SUBJECT: LA-6 Model.

DATE: October 31, 1933.

We release herewith the third installment of Machine Service Bulletin No. 161, Plates 22 to 28 inclusive, which illustrate and describe how to adjust the mechanism not covered in the first installment of this Bulletin.

FIG. 1

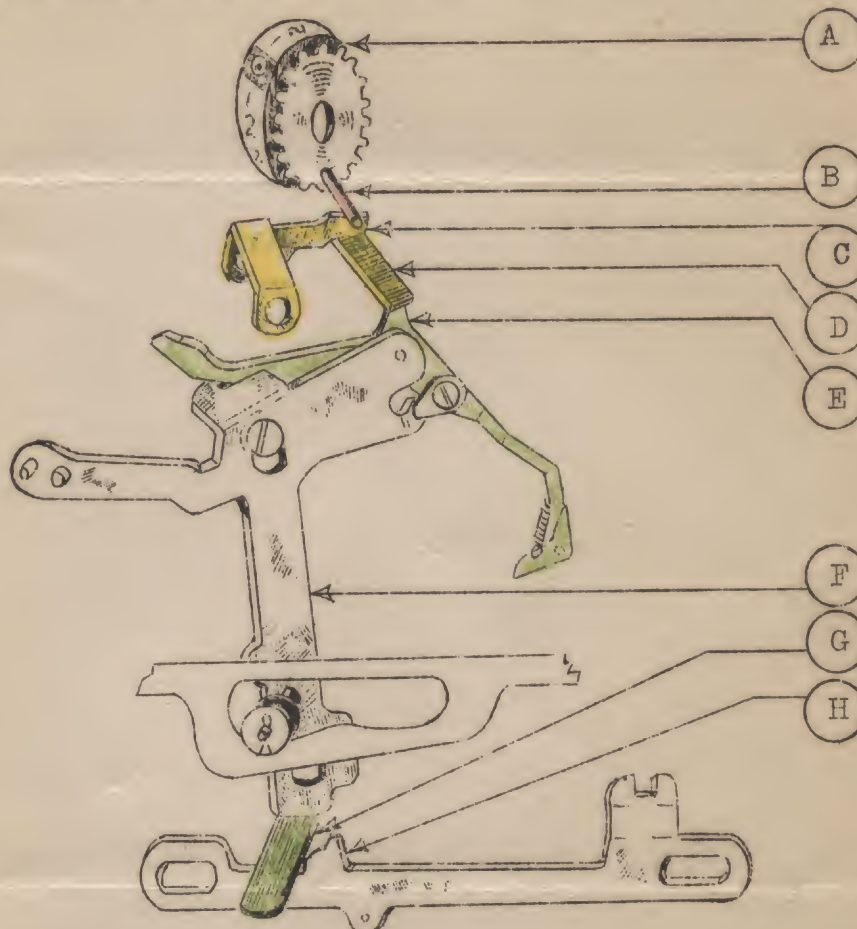
At the completion of a problem in automatic multiplication, the figure "one" which remained in the upper right hand dial is replaced by the "zero", due to the lug (D) seating on (E), causing an upward movement of (C) which restores the pin (B) to its neutral position. The above operations occur only when lug (G) is latched on (H). If lug (D) is bent too low, dial (A) will not clear out when the carriage crank is turned. If lug (D) is not bent low enough, the zero will not return to its neutral position.

When the lug (G) is unlatched from (H), clearance of .010 should exist between the bottom of lug (D) and the tip of (E). This clearance is obtained by bending lug (D) upward or downward to suit.

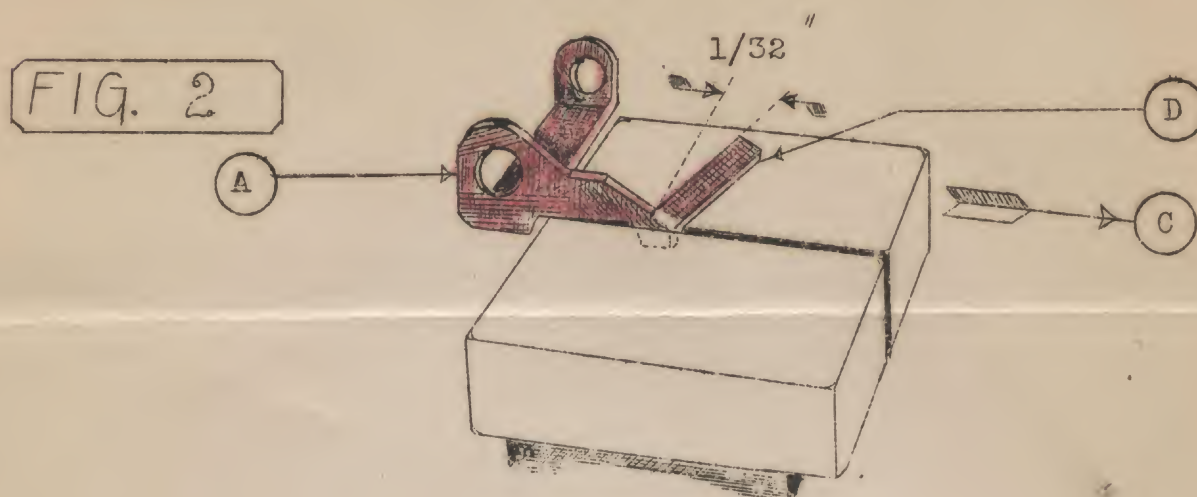
Before installing the return arm (A) in the carriage, clamp the arm securely in a vise as shown and using parallel pliers carefully bend the lug (D) in the direction of arrow (C) approximately $1/32$ ". This will assure an engagement of lug (D) with the point of (E), Figure 1, Plate 22.

FIG. 3

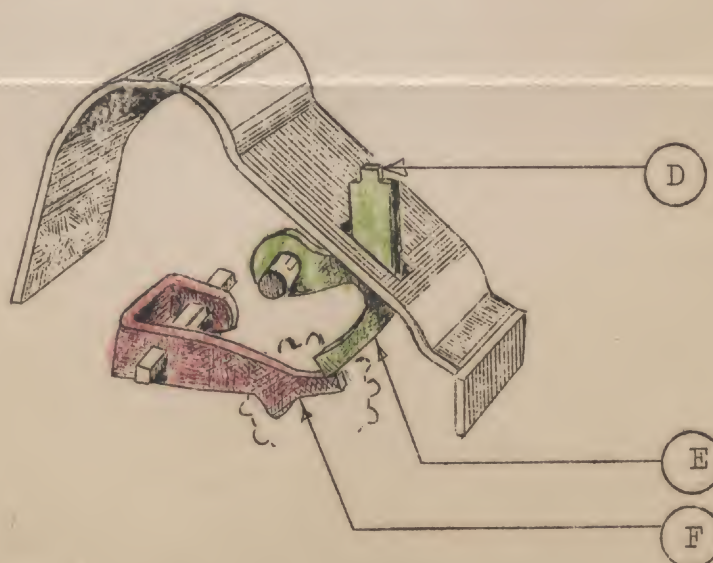
Register figures in the lower dials; turn the carriage clear crank slowly and note the engagement of the fingers (F) and (K) with the clear pins (G) and (L). The fingers should engage the pins (G) and (L) with an approximate $\frac{1}{3}$ hold, providing extension (H) engages pin (J) while the upper dials are being cleared. Set screws (E) provide an adjustment of pins (B) and (C) in relation to cams (A) and (D) for regulating the hold of the fingers (F) and (K) on pins (G), (J) and (L).

FIG. 4

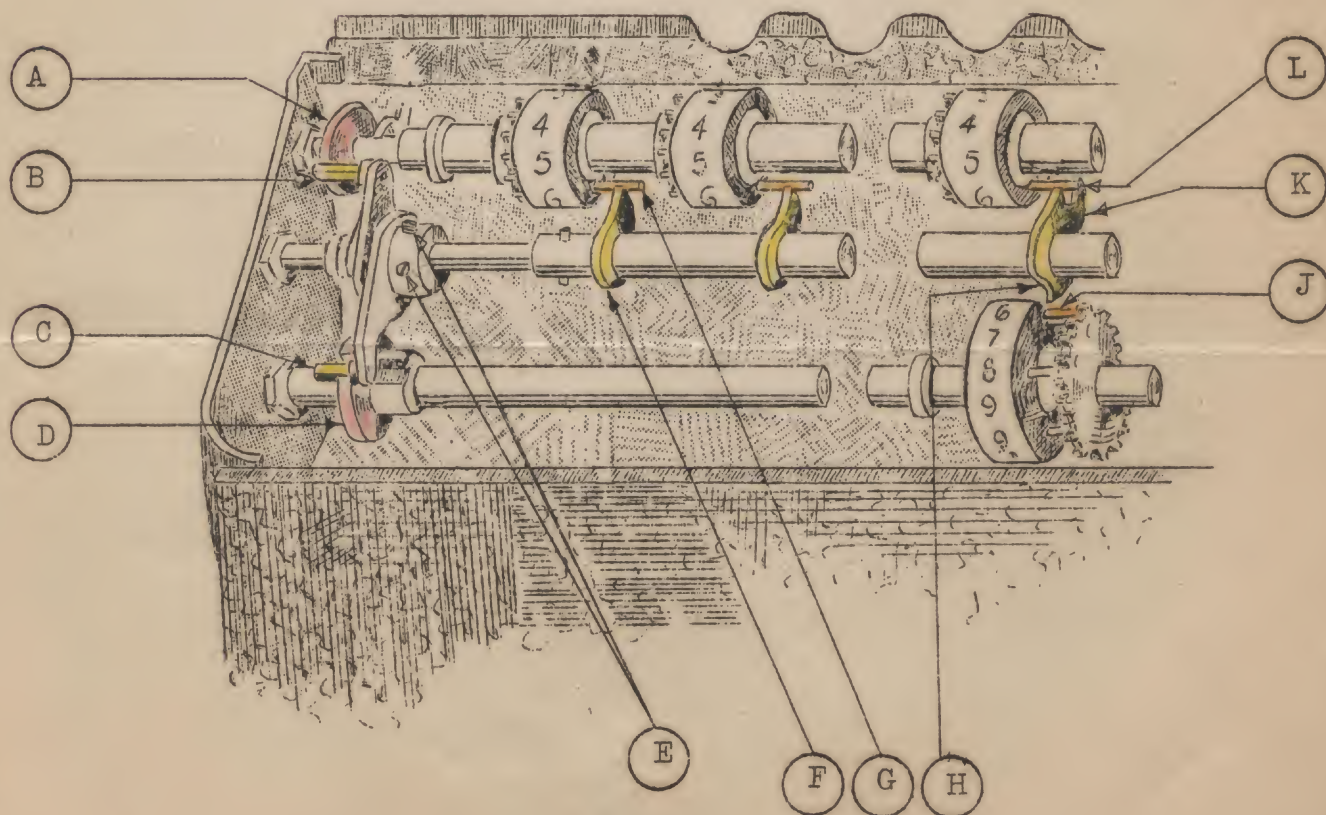
Set screw (A) is provided to limit the movement of arm (C) and the trip rod locator assembly (D), thus controlling the position of pawls (K) in their proper relation to pin (L), Figure 4, Plate 24, when setting in a constant on the registering dials. After the correct adjustment has been determined, tighten nut (B) securely.

FIG. 5

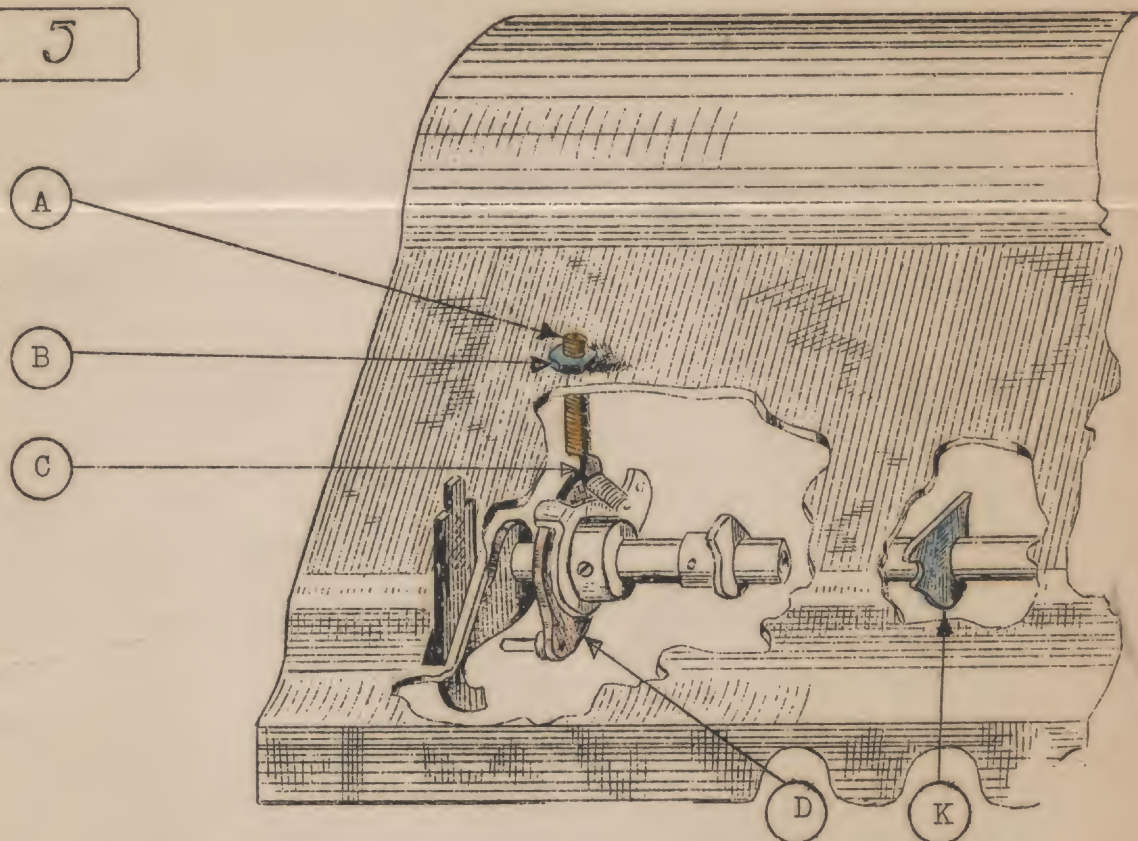
The lock bar (J) on the through unit (L) is adjusted to the carriage rack (M) by loosening screw (H) and positioning the lock bar (J) upward or downward to suit. After the correct position has been decided, tighten screw (H) securely.

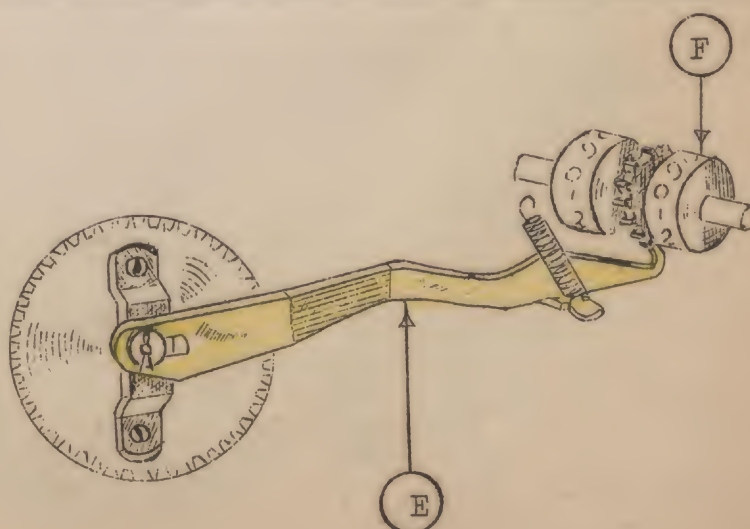
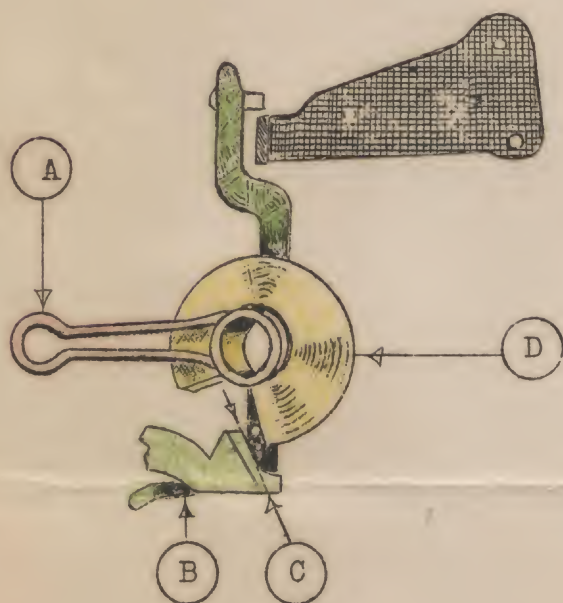
If during automatic division incorrect figures appear in the lower right hand dials, it is due to lock (B) striking the edge of cam (D) when the cycle stop arm is positioned against the bumper pad, thereby not allowing the lock to raise sufficiently high to permit the shifting of the carriage. This delay allows the counting finger (E), Figure 9, to engage the registering dials (F) twice and register accordingly.

This condition may be overcome by replacing the carriage lock cam with a cam having a larger notch or grinding $1/32$ " off the carriage lock (B) at (C), being careful to keep the original angle.

This condition may also be remedied in some cases by increasing the tension of the brake springs (A) on the carriage lock cams (D).

FIG. 10

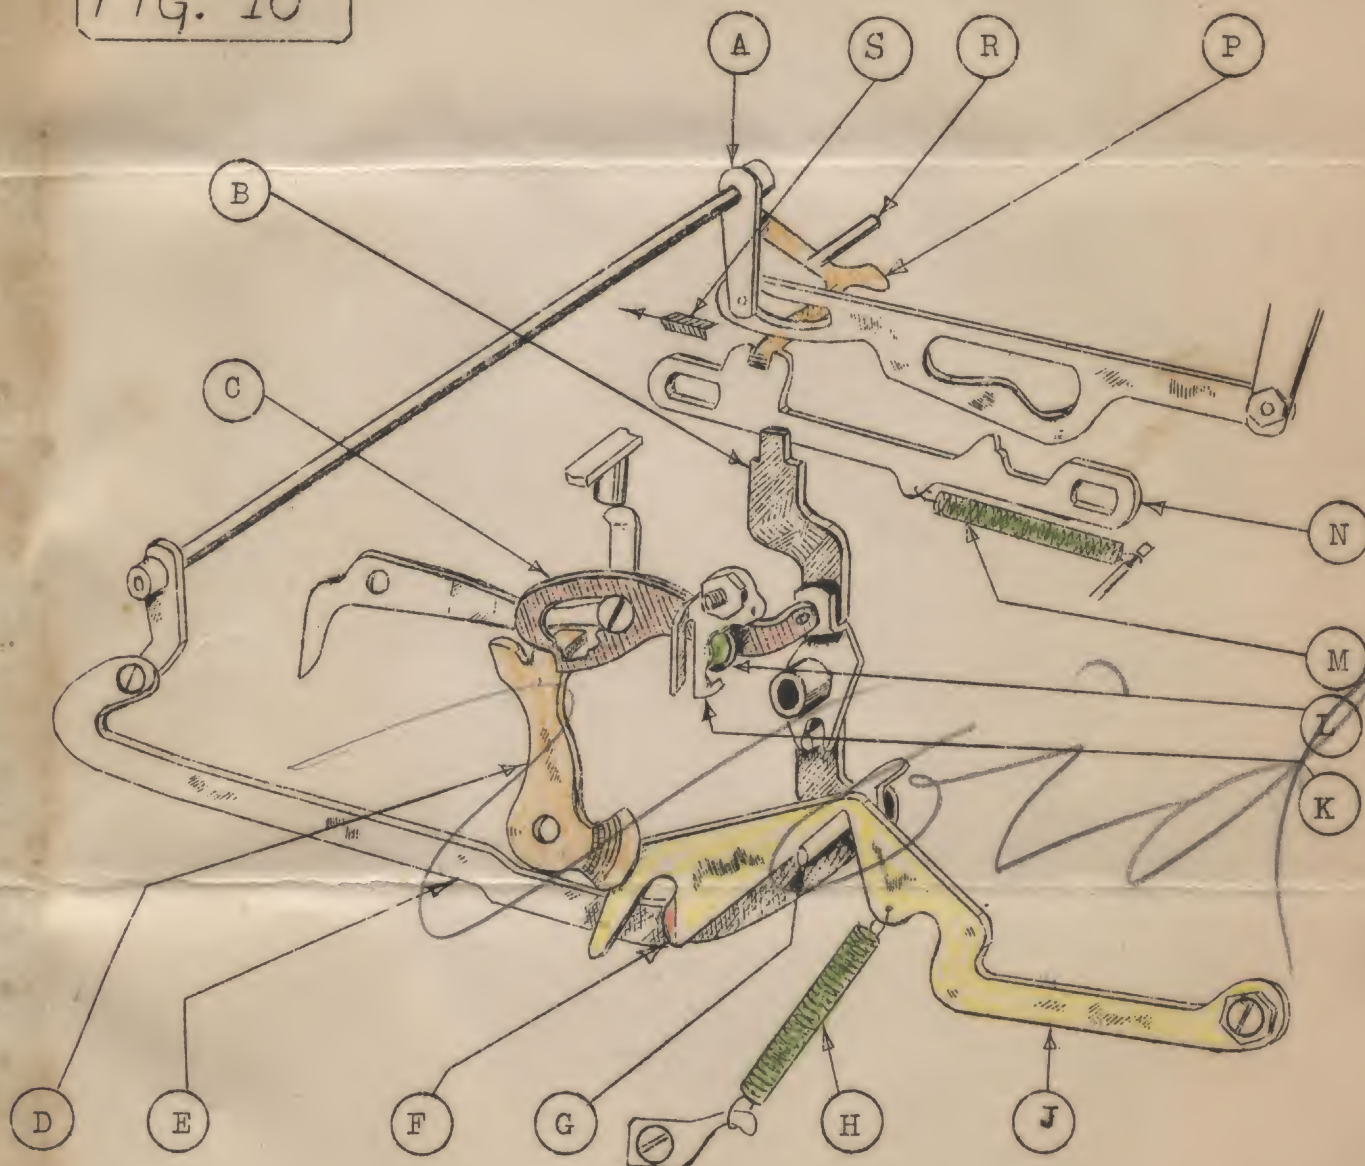
To remedy a condition wherein the division lever (B) fails to restore or restores sluggishly, a button of .040 thickness (L) has been added to the guide blank (K). This prevents the blank (C) from camming out of engagement with the restoring arm (D) as shown.
